Re: United Nuclear Corporation Churchrock Site
McKinley County, NM

Re: United Nuclear Corporation Church Rock Site
UNC Comments on Draft Second EPA Five-year Review Report

**Re: Review of May 2003 Draft Five-Year Review Report, Section Five-Year Review Report
for United Nuclear Corporation, OU-1, Church Rock Site, McKinley County, New
Mexico, May 2003.**

Figure 1
Church Rock
Second Five-year Review

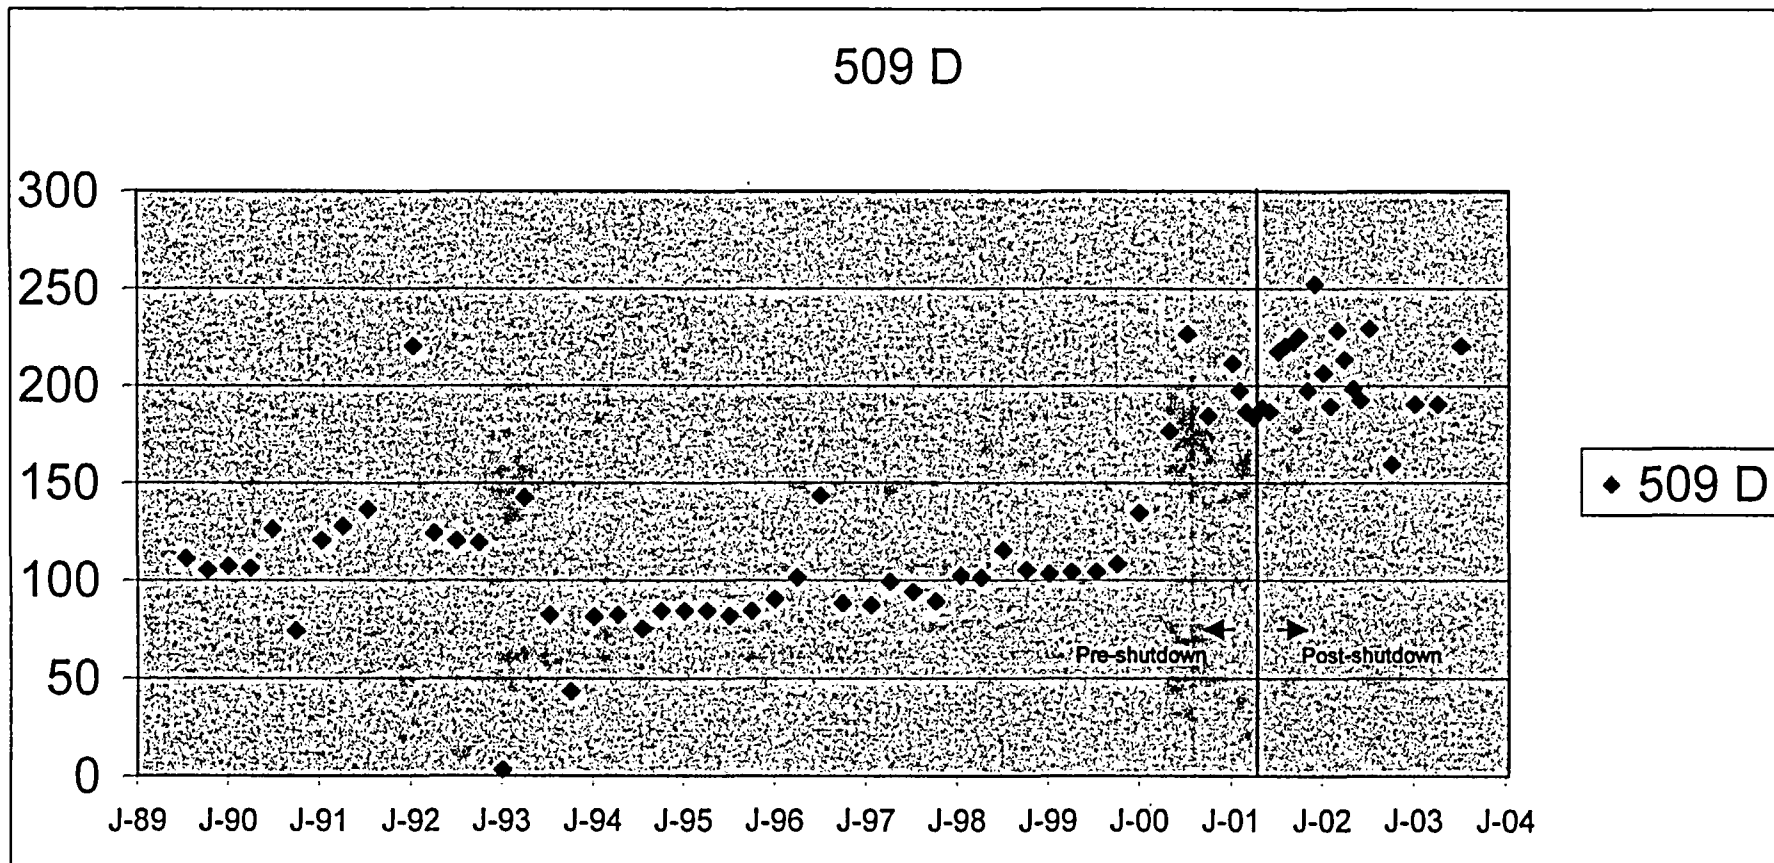
Well 509-D Concentrations of uranium at well 509-D (Figure 1) began to rise one full year before the pumping system shut down, and they have fluctuated randomly between 150-250 ug/L ever since shutdown. There is no trend in post-shutdown data. In addition well 509-D is located outside of the zone of influence of the former pumping wells. Thus, the uranium data for well 509-D undercuts EPA's thesis that pumping worked. To the contrary, using EPA's reasoning, it would indicate just the opposite because concentrations rose while the pumps were on and stopped rising when they were shut-off.

Figure 2
Church Rock
Second Five-year Review

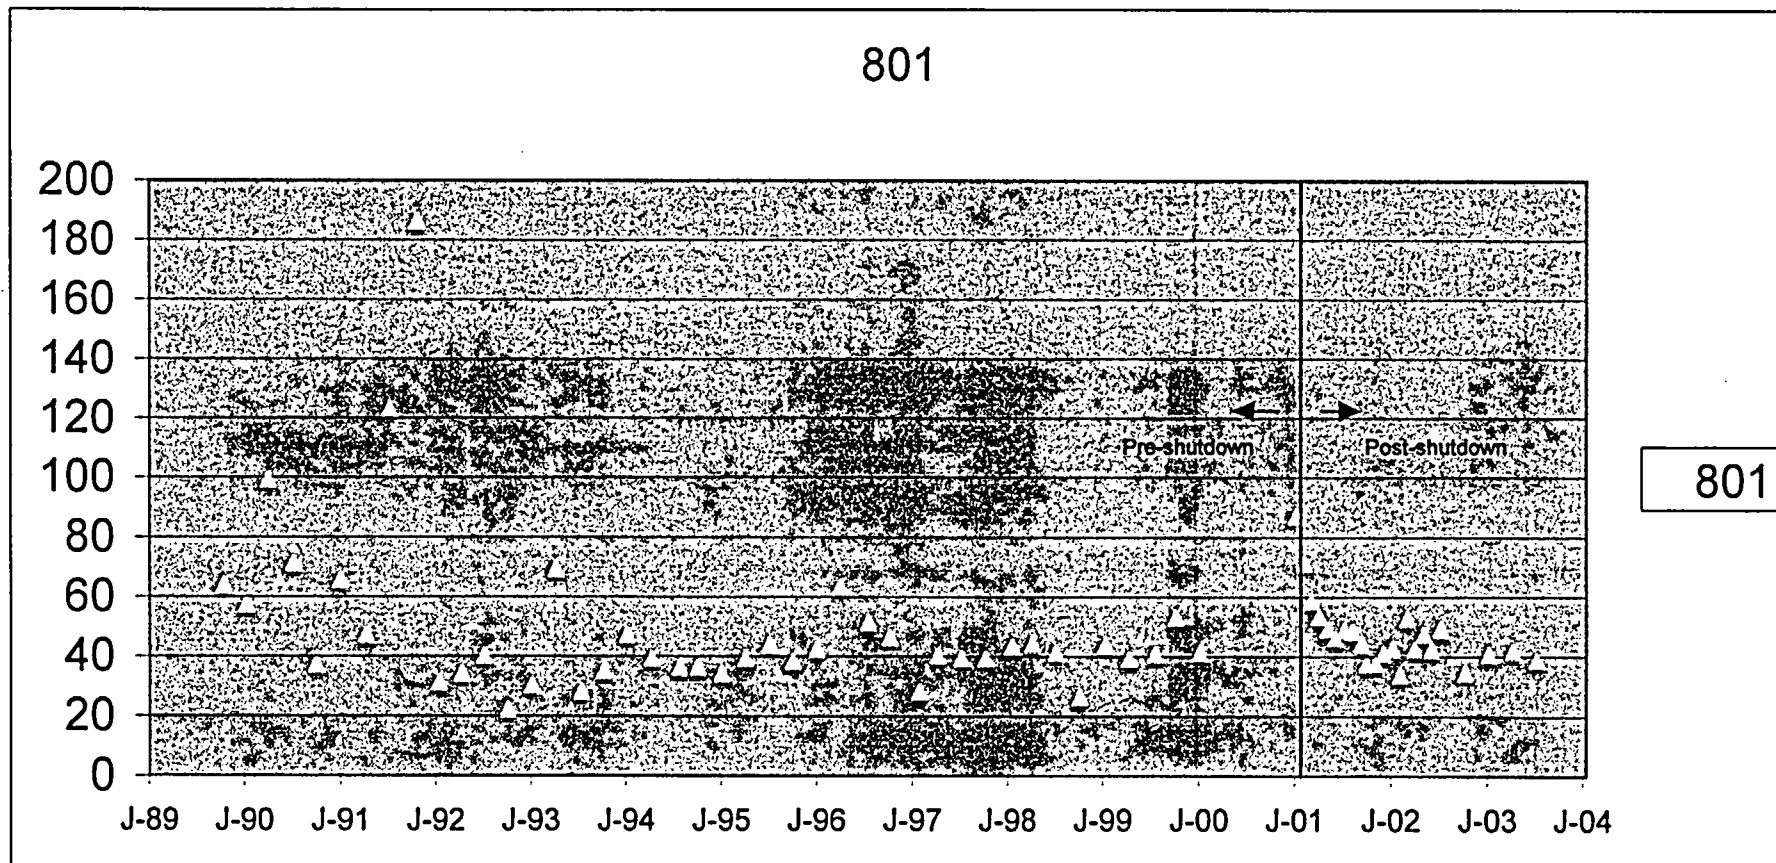
Well 801 Concentrations of uranium at well 801 (Figure 2) were at their highest just before the shutdown and thereafter steadily declined, throughout the natural attenuation test and beyond, as EPA concedes. They decreased and stabilized at concentrations approaching the long-term average

concentration during pumping. Certainly this data does not suggest that pumping was advantageous. If anything it indicates that, given enough time, slugs of uranium-bearing water have a tendency to approach a concentration that is constant, whether or not the pumps are running.

Figure 3
Church Rock
Second Five-year Review

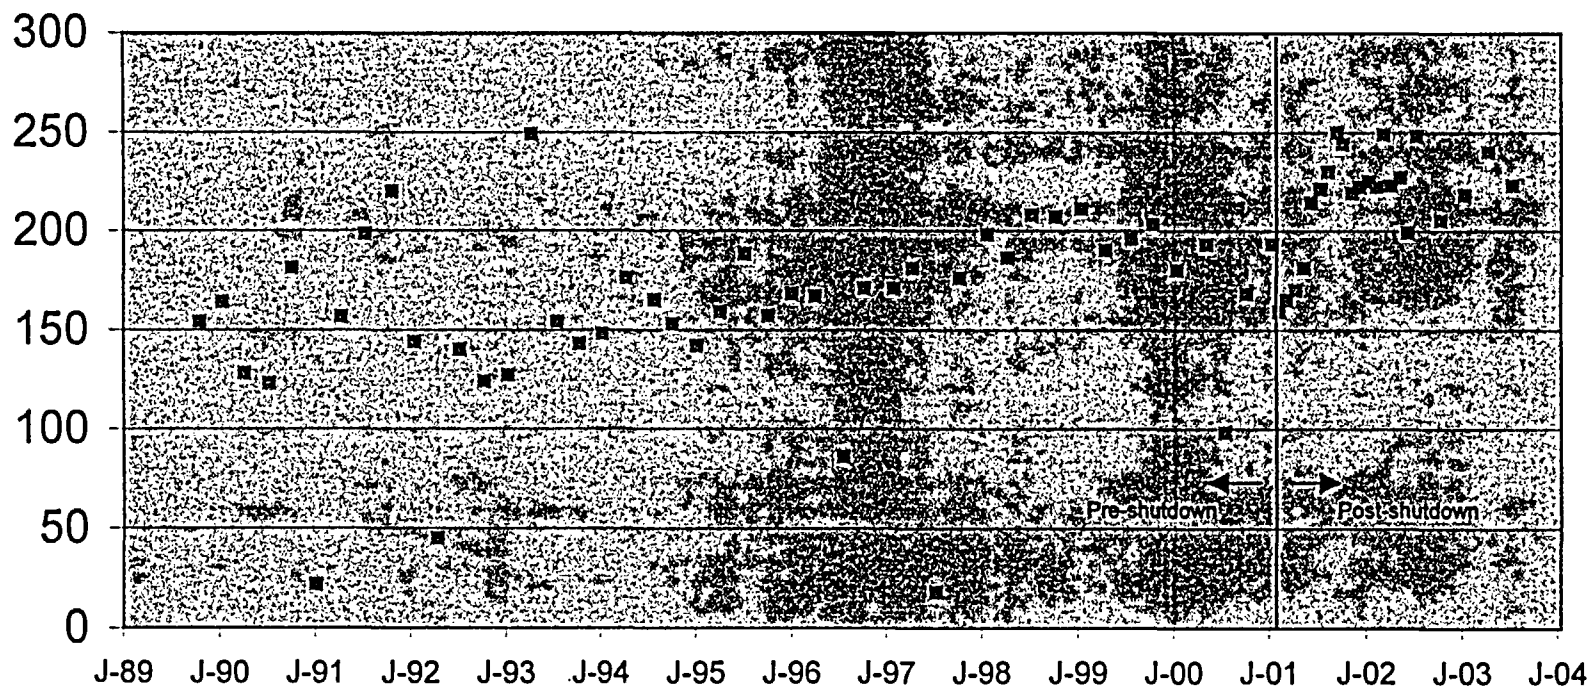
Well 802 Well 802 was a pumping well that was shut down on January 8, 2001. Concentrations of uranium at this well (Figure 3) are higher than the concentrations just prior to shutdown, and they should be because there is no longer the dilution of less-impacted groundwater being drawn into the well and/or there is re-saturation of alluvium as the water levels rises. This is a normal, highly localized condition that should not be interpreted as demonstrating any real benefit or protectiveness. Moreover, the data since shut down do not show an increasing trend. They are variable, but steady within the 200-250 ug/L range. UNC expects that the concentrations will eventually decline naturally as they have done for well 801.

Figure 4
Church Rock
Second Five-year Review

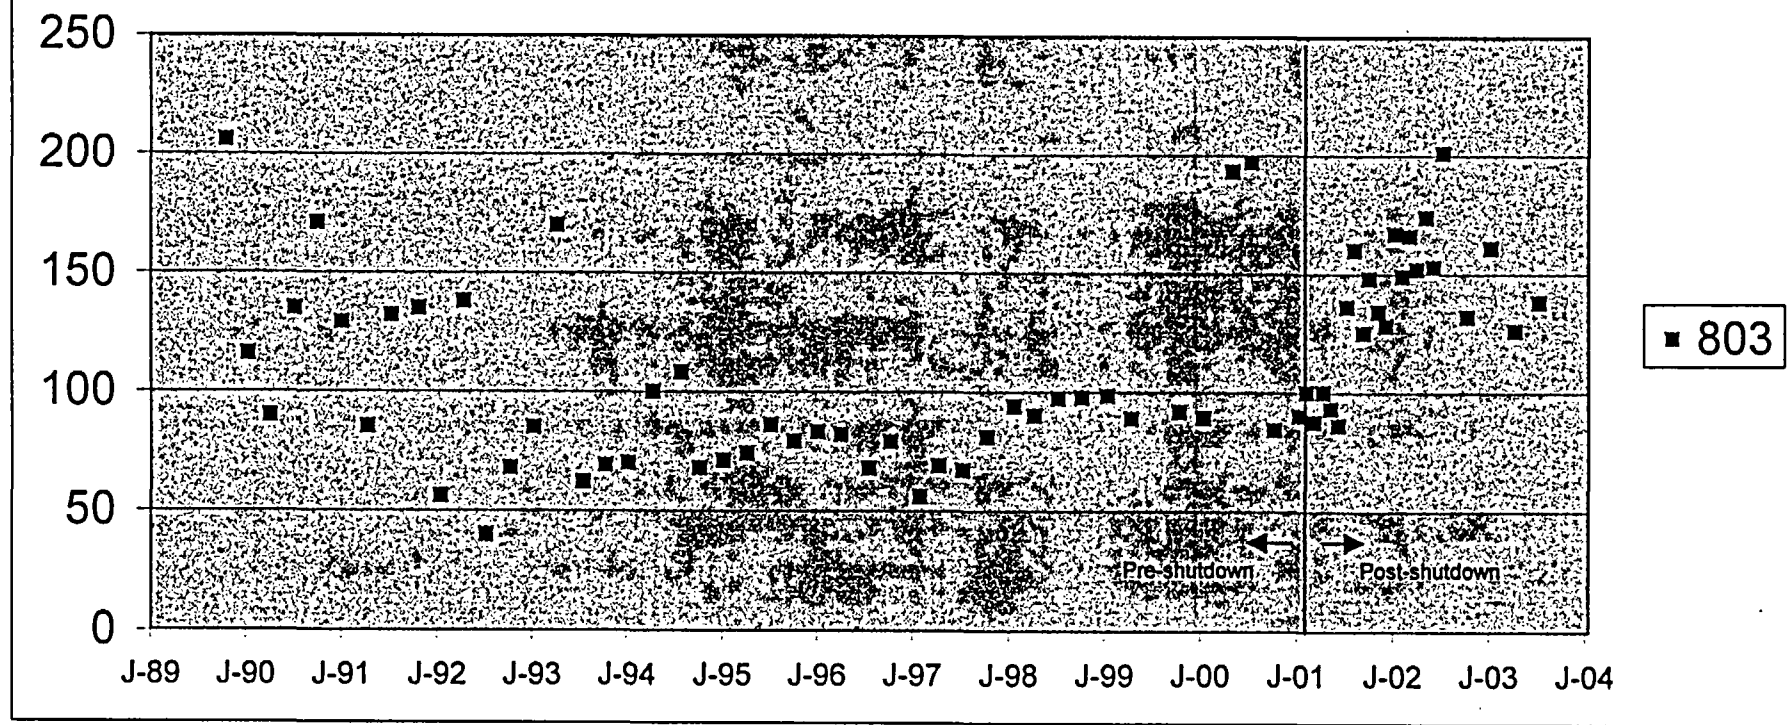
Well 803 This well is similar to 802, and as can be seen on Figure 4 only one of 21 samples since shutdown showed higher uranium concentrations than the two high concentrations that were analyzed before the shutdown in 2000. Frankly, this is statistically remarkable because the frequency of sample collection was so much greater after the shutdown. Therefore uranium concentrations in well 802 indicate that natural attenuation is equivalent or better than pumping. Furthermore, once the most recent data are considered, the data related to the early shut down period no longer supports any statistically defensible conclusion that there is an upward trend in concentration. UNC will provide the statistical analysis that supports this conclusion under separate cover.

Figure 5
Church Rock
Second Five-year Review

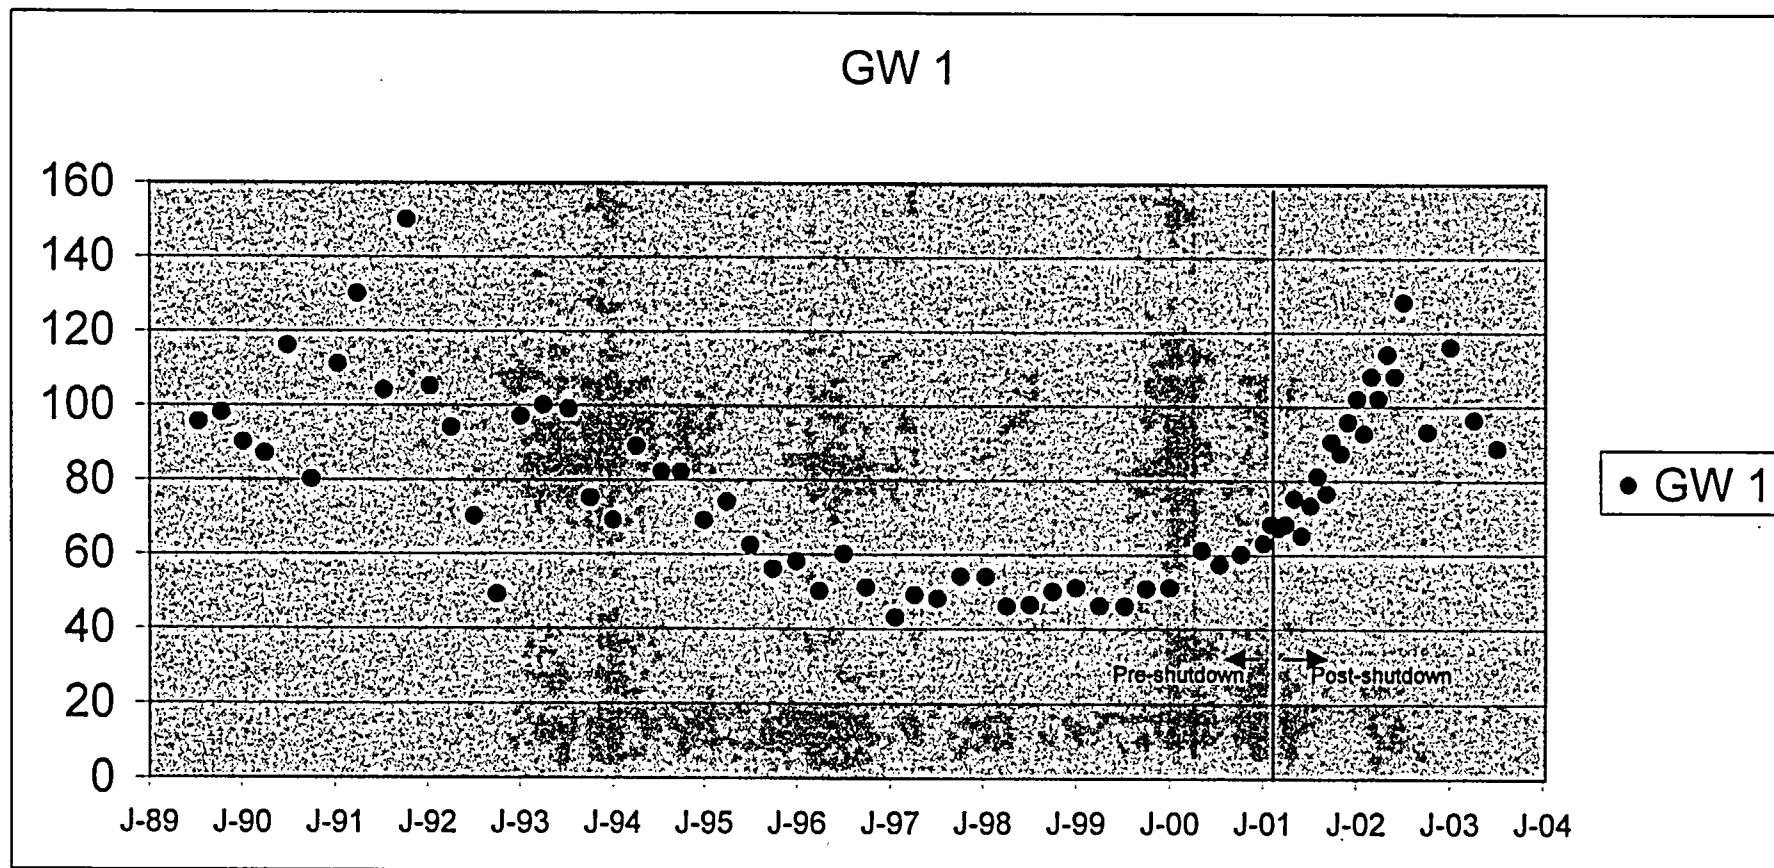
Well GW1 EPA asserts a "dramatic" increase in uranium concentrations in Wells GW1 from a stable trend while pumping was off during the NA test. Although uranium concentrations appear – at least initially – to increase (Figure 5), when the data is analyzed further, a different picture emerges. The upward trend of increasing concentrations of uranium preceded the pumping shutdown, and thus cannot be attributed to the lack of pumping. Second, more recent data shows concentrations are declining, suggesting that conditions have stabilized and whatever initial increase occurred was an anomaly. This pattern is not unusual, having occurred at many wells over the long term – see e.g., Well 801, GW1 and GW 2. Taken as a whole, the most that can be concluded from the data is that pumping has not made any discernable difference in the concentration or migration of uranium in groundwater.

Figure 6
Church Rock
Second Five-year Review

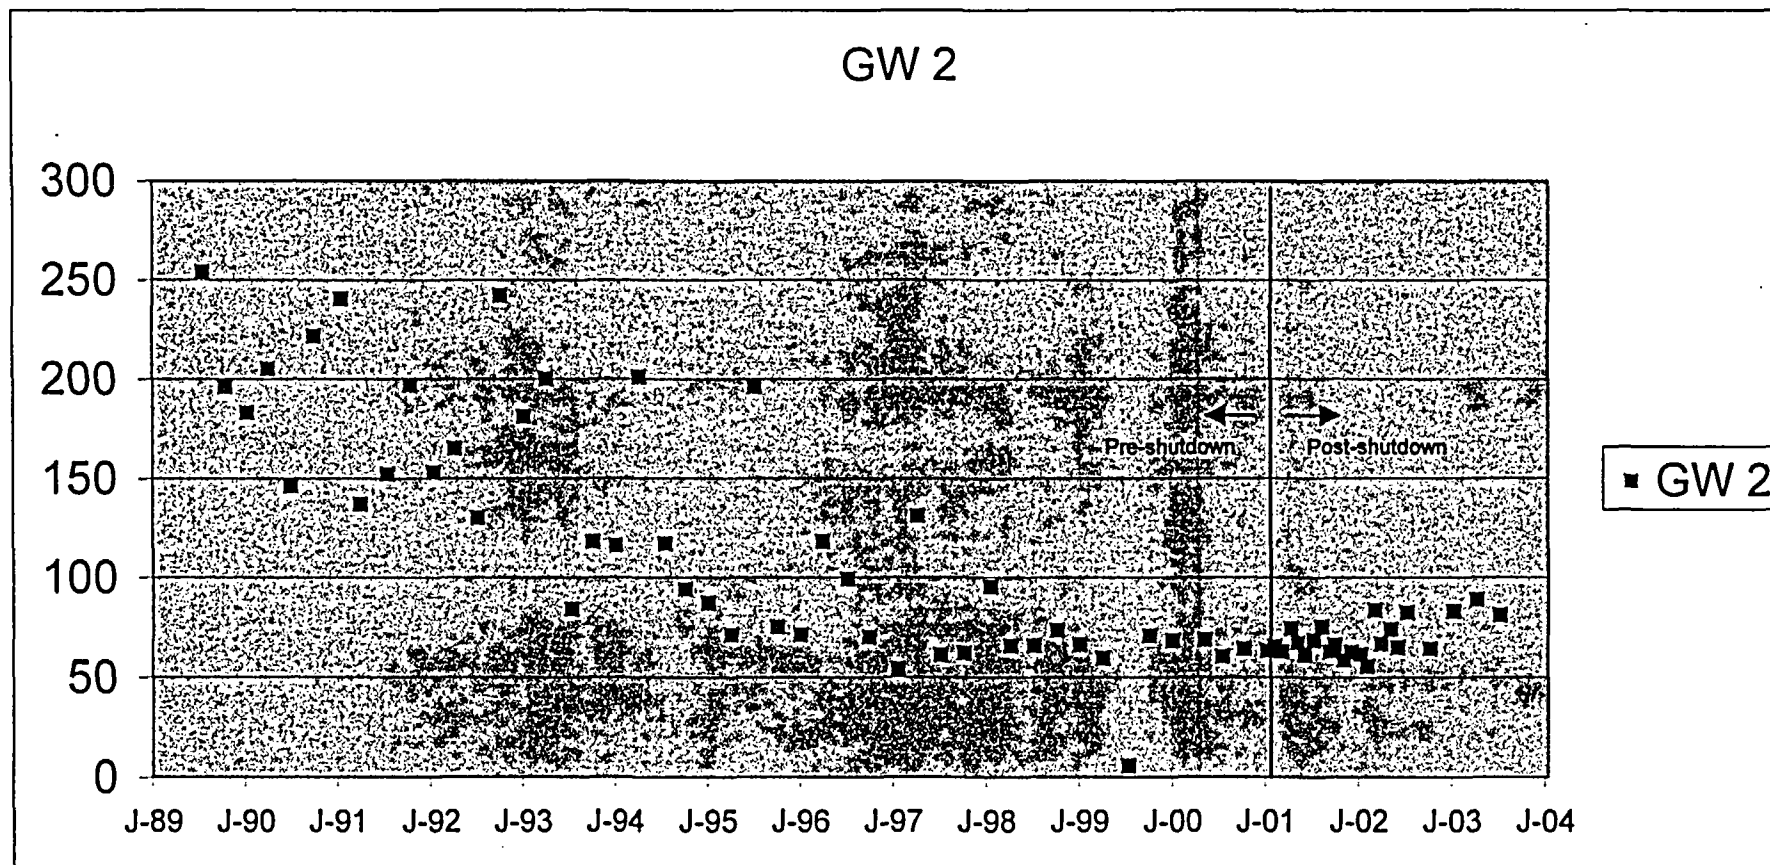
Wells GW-2 and GW-3 Wells GW-2 and GW-3 are similar (Figures 6 and 7, respectively). Well GW-2 has no statistically definable trend following

shutdown, and well GW-3 has a statistically definable upward trend, though it is weak. When the last six months of data are also viewed, it seems that further monitoring is warranted instead of concluding that the pumps should be activated.
